16-bit MCU with 512 KBytes Flash and 36 KBytes RAM memories

Introduction

This errata sheet describes all the functional and electrical problems known in the ABG silicon version of the ST10F273M.

Table 1. Functional problems of the ST10F273M-ABG

Figure 1. ADC injection theoretical operation

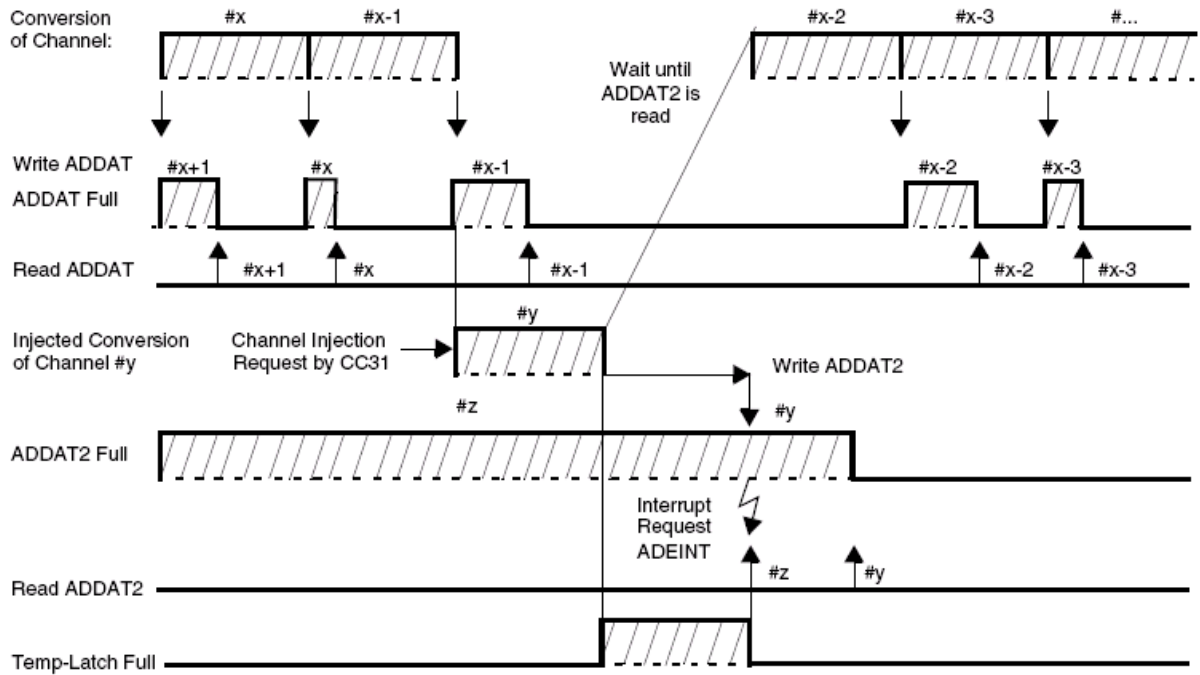
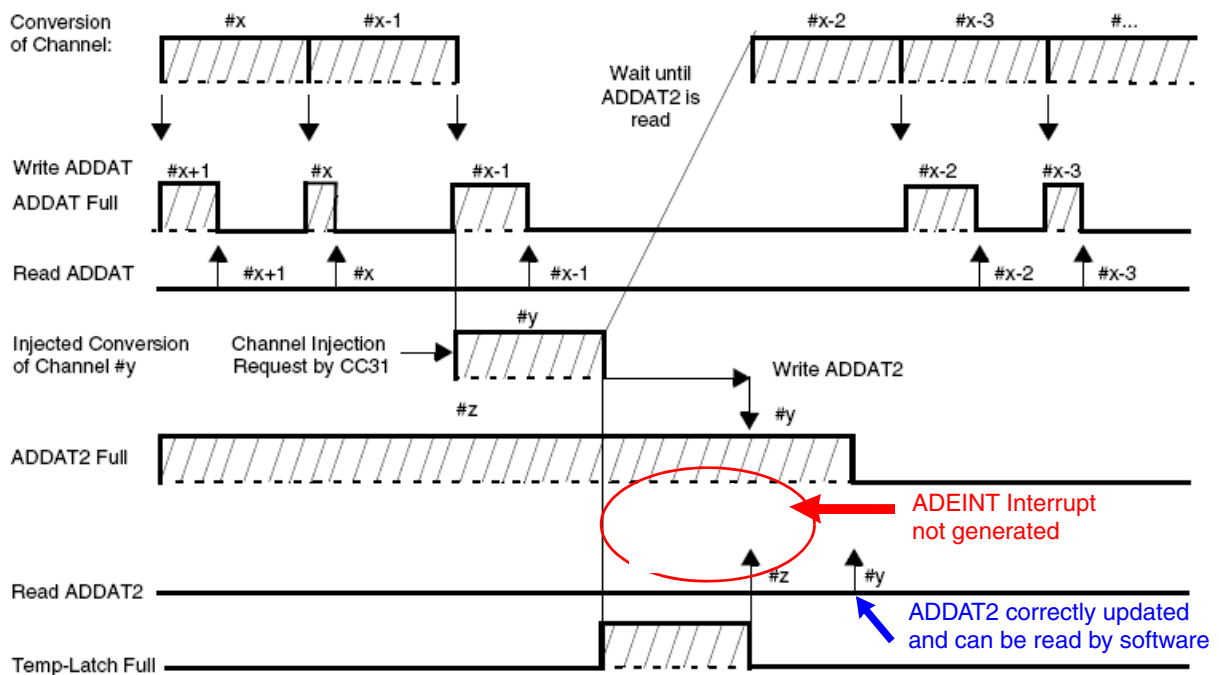
For a correct functionality as soon as ADDAT2 register is read then the last converted value should be moved from temporary register to ADDAT2 and the ADEINT interrupt request should be issued. This would allow the CPU to read the last converted value. See [Figure 1](#).

In the real situation as soon as ADDAT2 register is read then the last converted value is correctly moved from temporary register to ADDAT2 but **the ADEINT interrupt request is not received by the Interrupt Controller (see [Figure 2](#))**. As a consequence the CPU/PEC will never know that a new converted value is ready to be read in ADDAT2 register and therefore at the following injection request the ADC will fill the temporary register again (without generating any ADEINT interrupt request) and then will stall the ADC for any further conversion. The ADC will stay in the “wait for read ADDAT2 register” condition forever.

1. Read the ADDAT2 register twice at the end of every injected conversion (also prevents stall condition to occur)
2. Disable then re-enable the Wait For Read mode

Figure 3. ST10 in slave mode

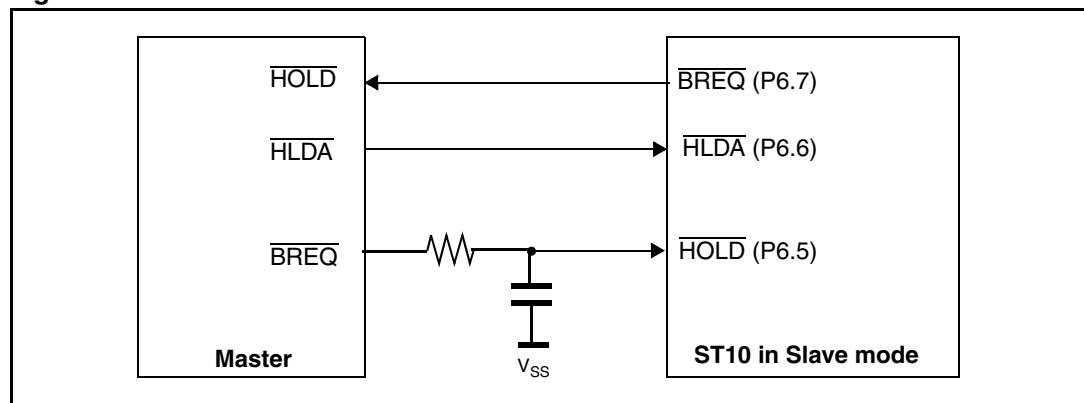
When using external bus arbitration via HOLD-function with the ST10F272M/ST10F273M configured as a slave, sporadic bus errors may occurs.

After the slave has been granted the bus, the slave deactivates \overline{BREQ} sporadically for a short time, even though the bus access of the slave has not been completed. The master then starts its own bus access, leading to a bus conflict between master and slave.

In order not to produce any spurious \overline{BREQ} pulse during a Slave External Bus Arbitration Phase, it is necessary to guarantee that the distance between the \overline{HOLDA} assertion (Bus Acknowledge from Master device) and the following \overline{HOLD} falling edge (Bus Request from Master) is greater than three clock cycles.

This can be implemented by delaying the \overline{HOLD} signal with a RC circuit as shown in the [Figure 3](#) below.
